Name of Proposed Subdivision LAKE RIDGE PARK - BOTO ADDITION

**DRAINAGE AREA MAP**  
LAKE RIDGE PARK - BOTO ADDITION  
CITY OF ROCKWALL  
ROCKWALL COUNTY, TEXAS

Re: 1st Review  
Lake Ridge Park-Boto Addition

RE: Second Review  
Lake Ridge Park-Boto Addtn.  
ROK 84867

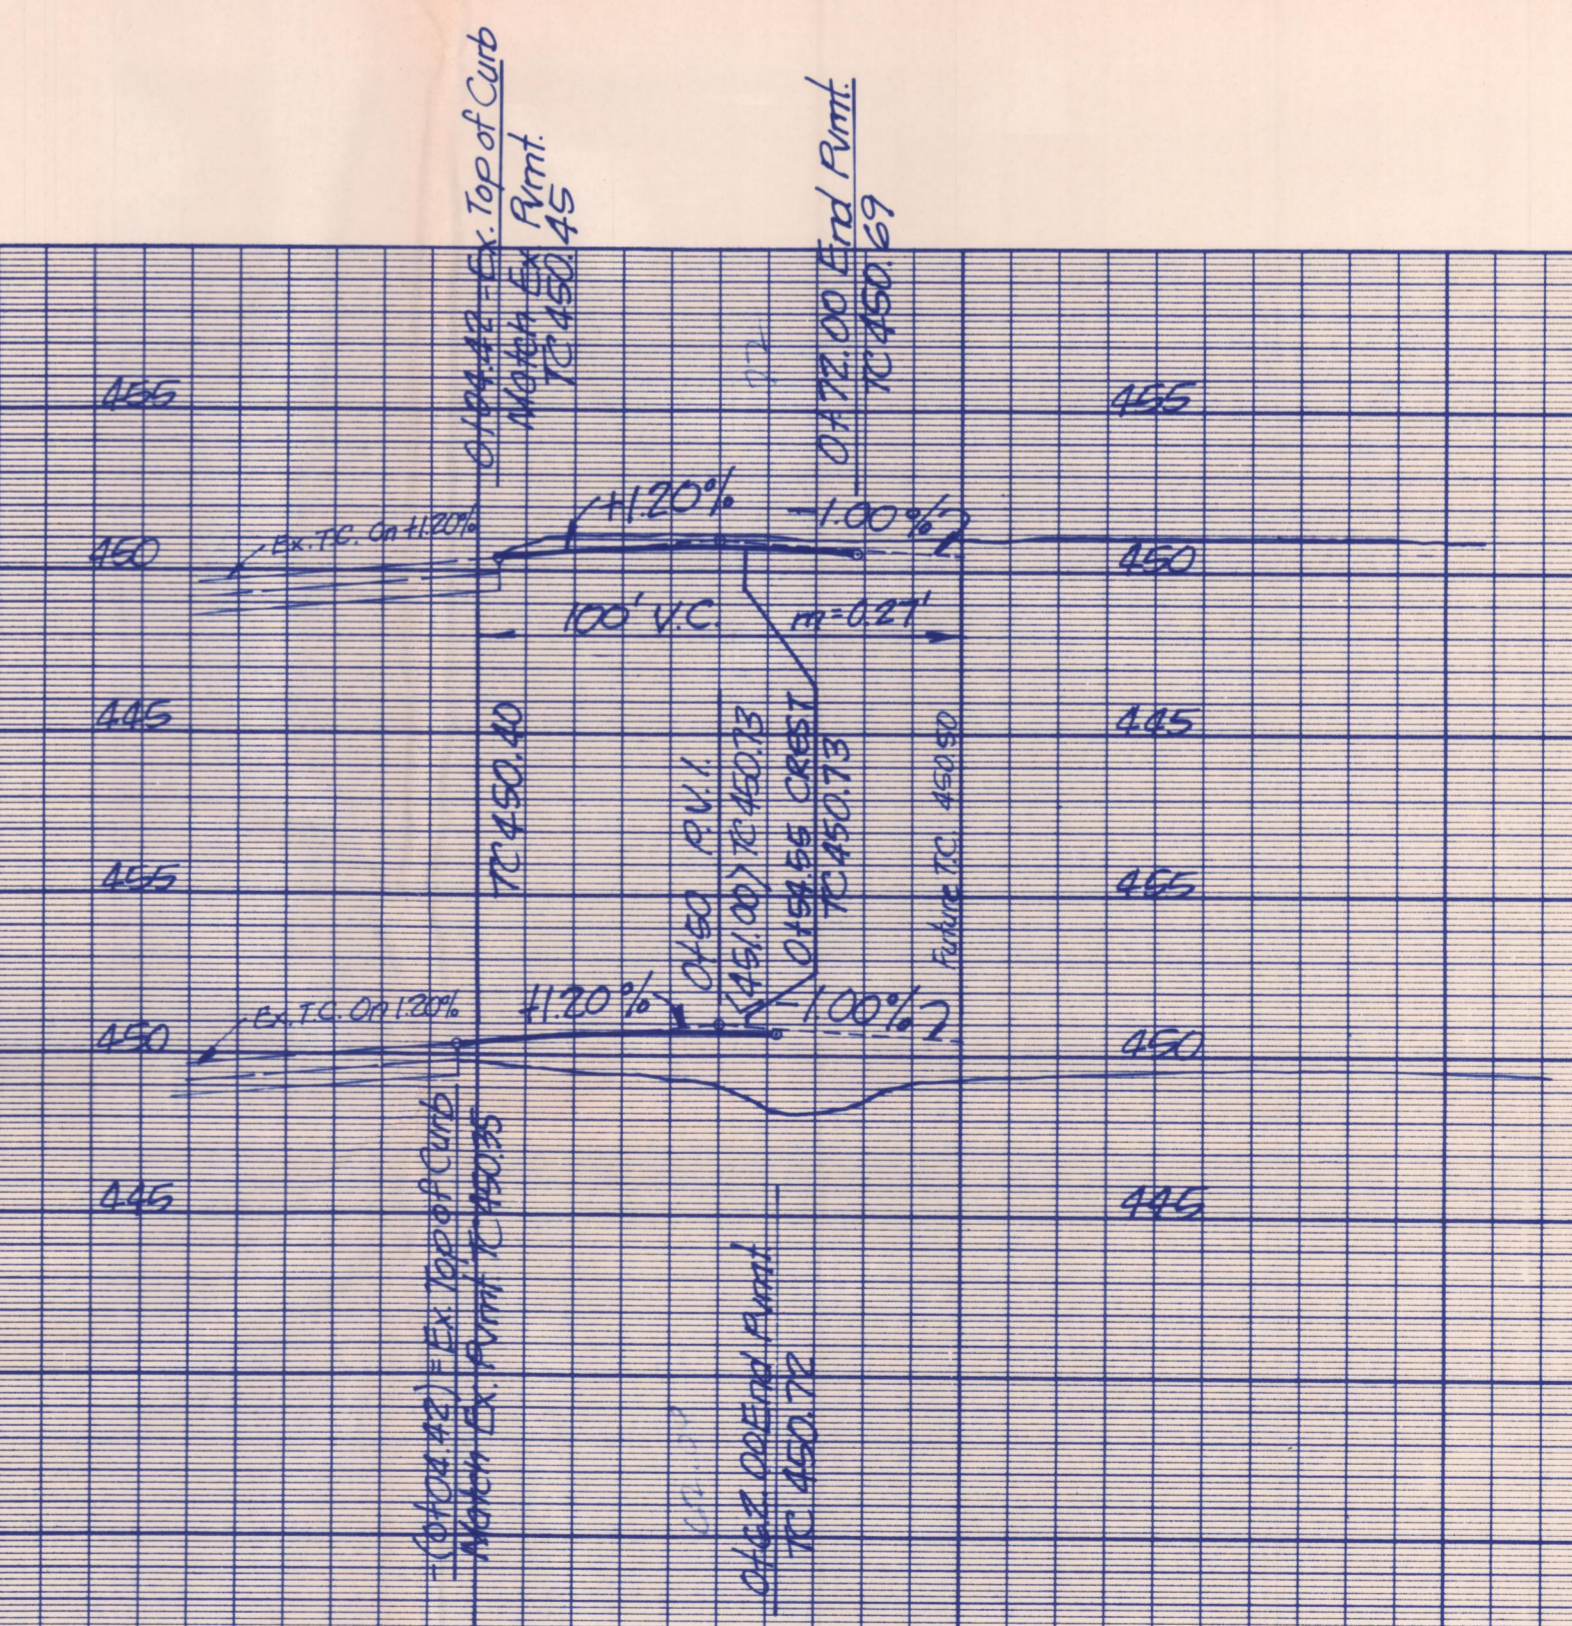
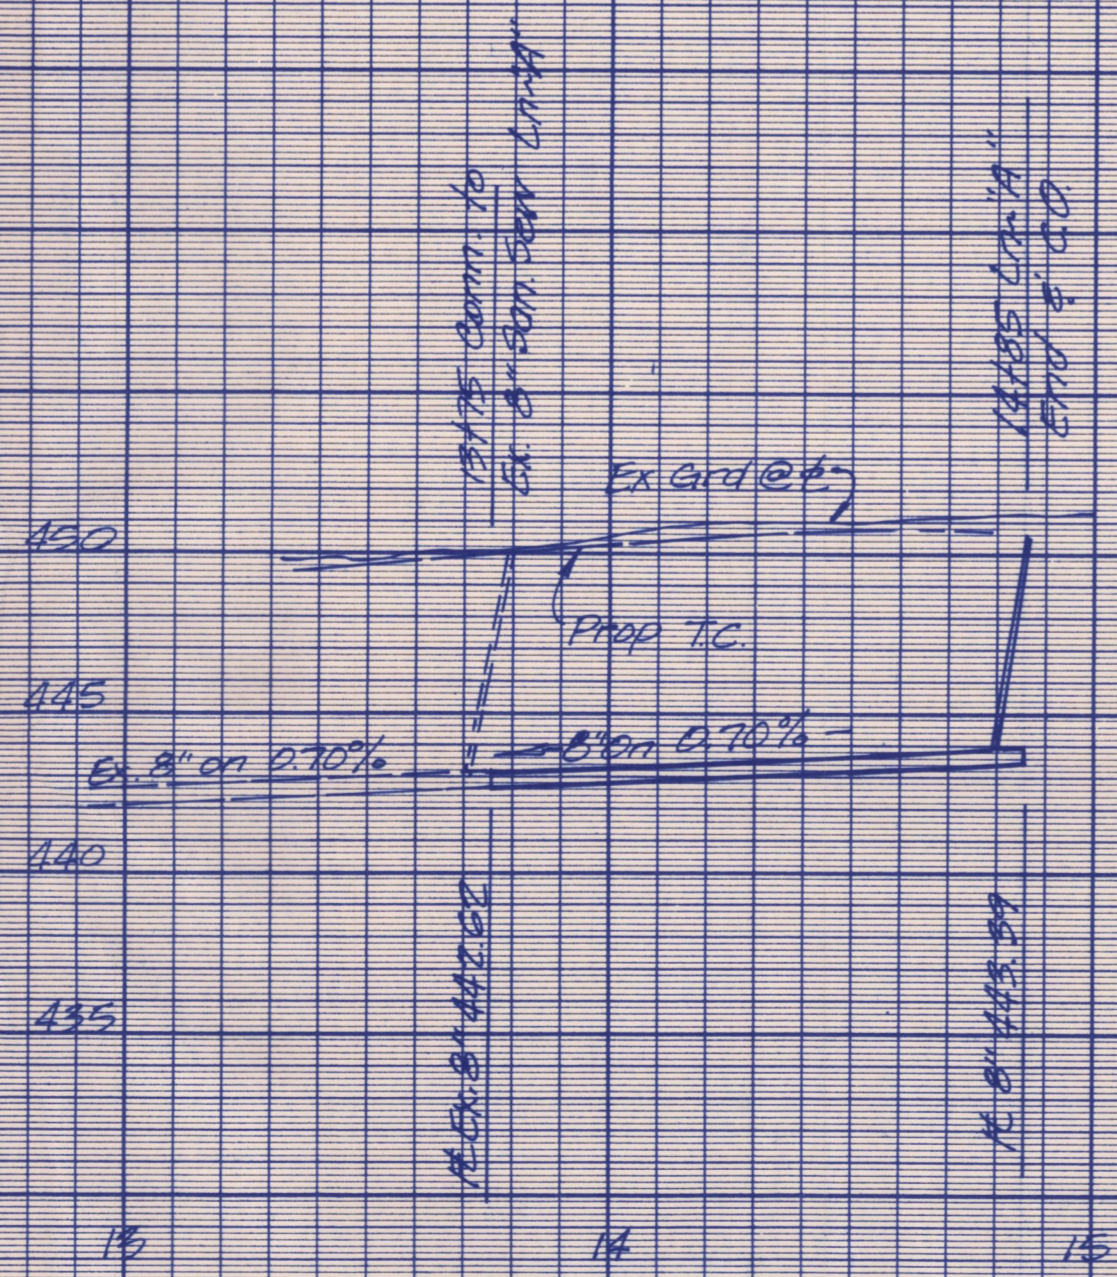
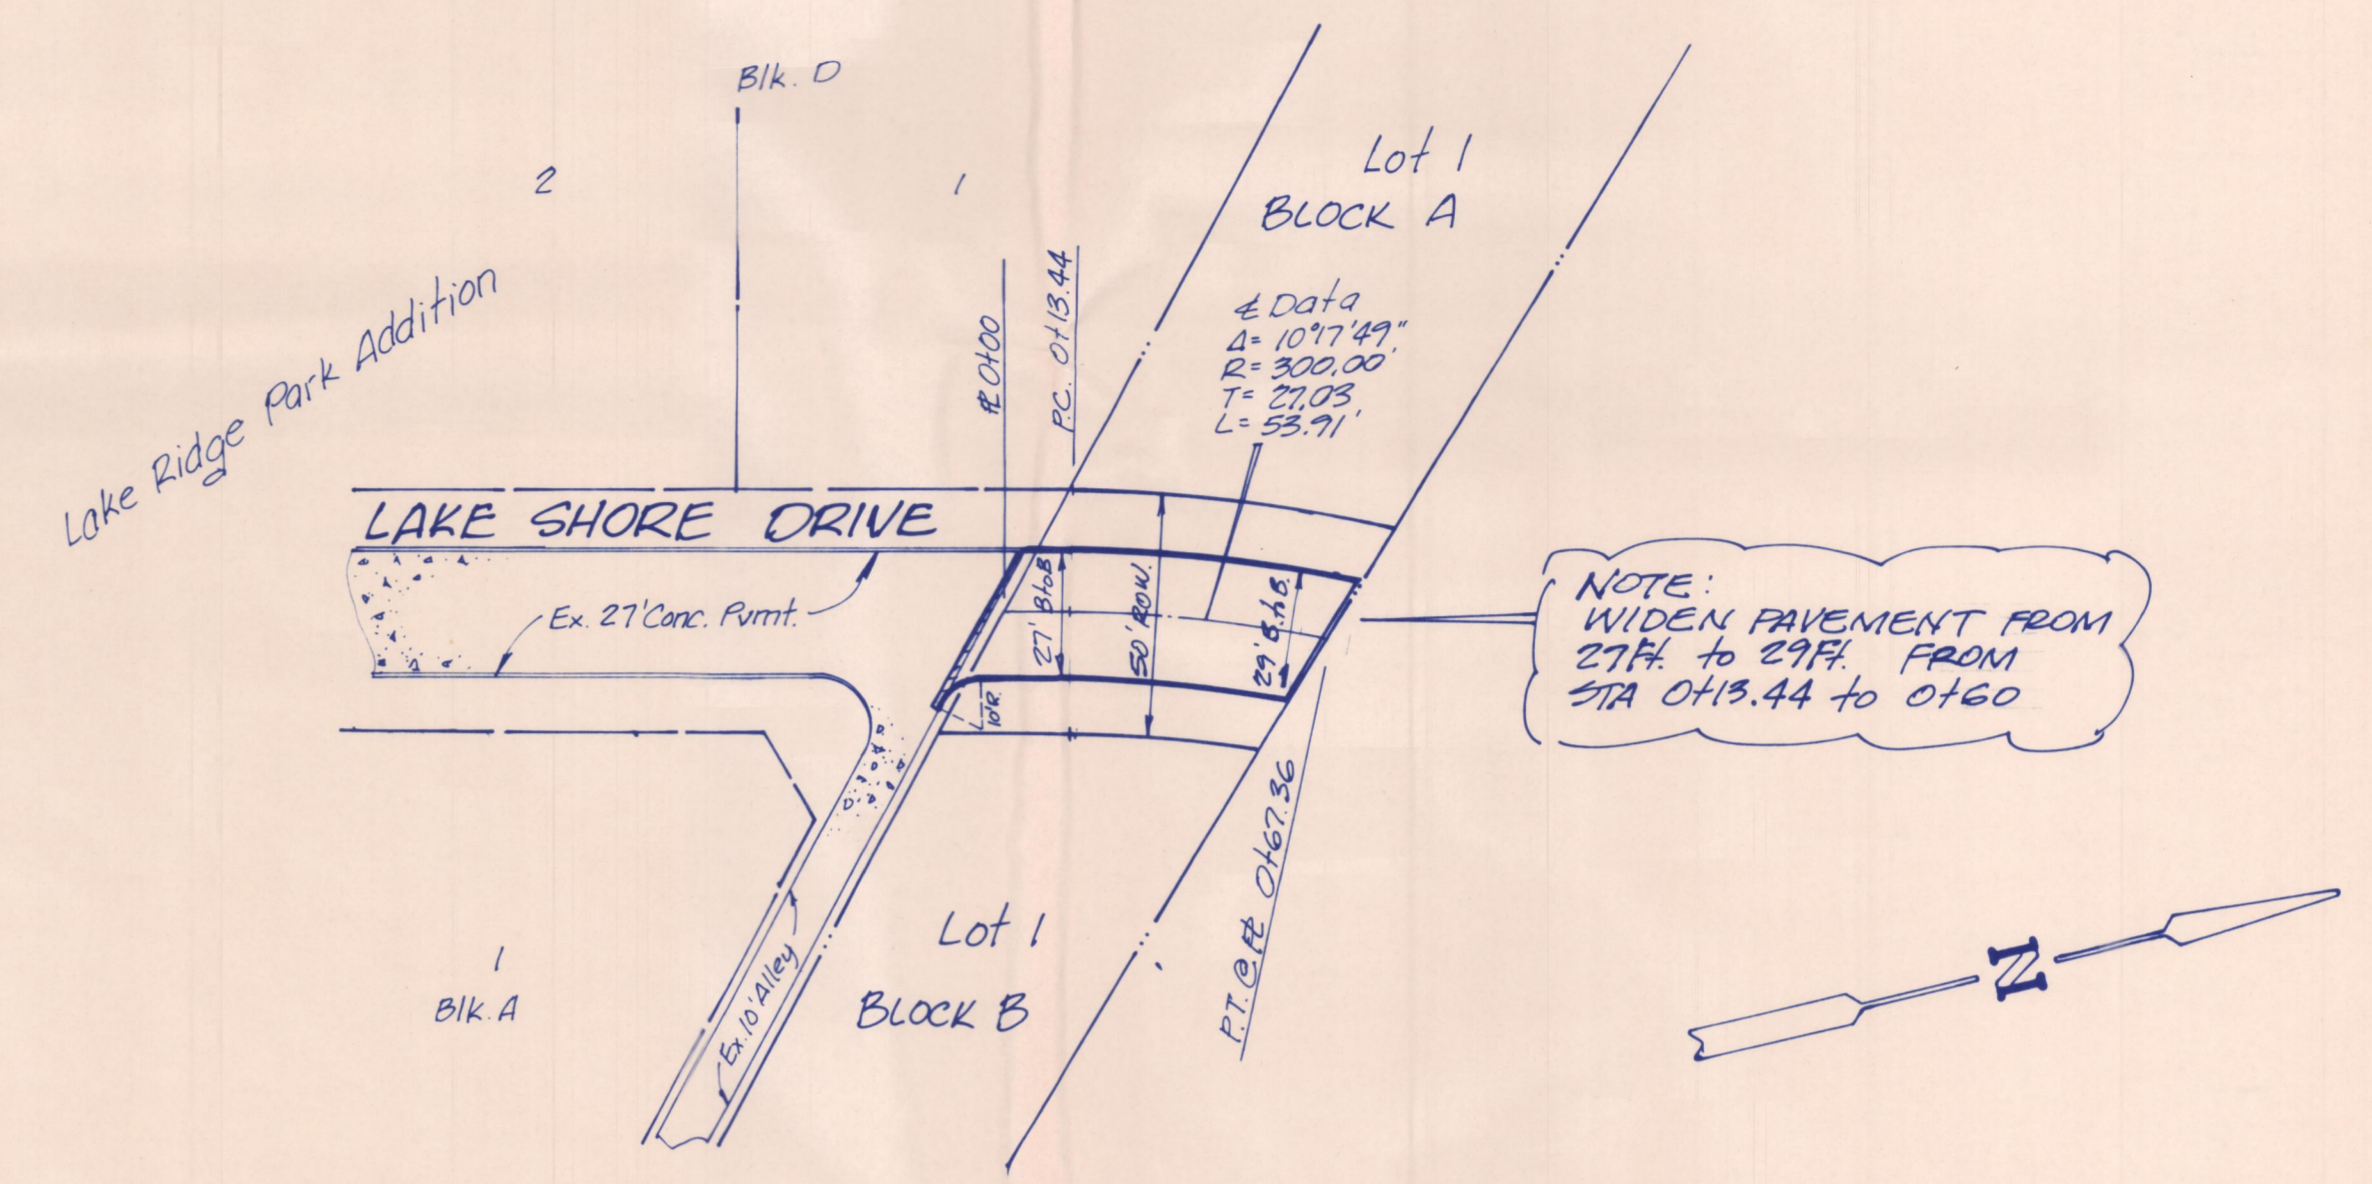
1. A general vicinity map should be provided.
2. The name of the street to be extended on the survey plat conflicts with the corresponding street name on the drainage area map.
3. The flow rate and direction of flow for Area 1 should be shown on the plan view. The size of the existing storm sewer should be indicated. Additional calculations should be provided in order to determine if the existing inlets and storm sewer can carry the additional flows without causing ponding of water during flooding conditions.
4. An inlet time of 15 minutes has been used for the drainage calculations. For the length of the streets proposed, an inlet time of 10-minutes and thus a rainfall intensity of 6.2 inches may be more appropriate.

The direction of flow for Area 1 has been provided as shown on the plan view. The storm drainage calculations have been provided as requested. However, the size of the existing storm sewer has not yet been indicated. We recommend that the Developer research the designed capacity of the existing storm sewer and inlets to determine if the discharges can be carried.

The other comments in the first review have been addressed. Although the northern drainage boundary has been altered from those proposed in the first set of plans due to future development, the information provided appears to be sufficient. If the future development is not completed, the drainage area contributing to the existing storm sewer will be greater.

ALL ITEMS IN LETTER DATED OCT. 22, 1984  
HAVE BEEN ANSWERED PER COMMENTS  
MADE BY CITY ENGINEER
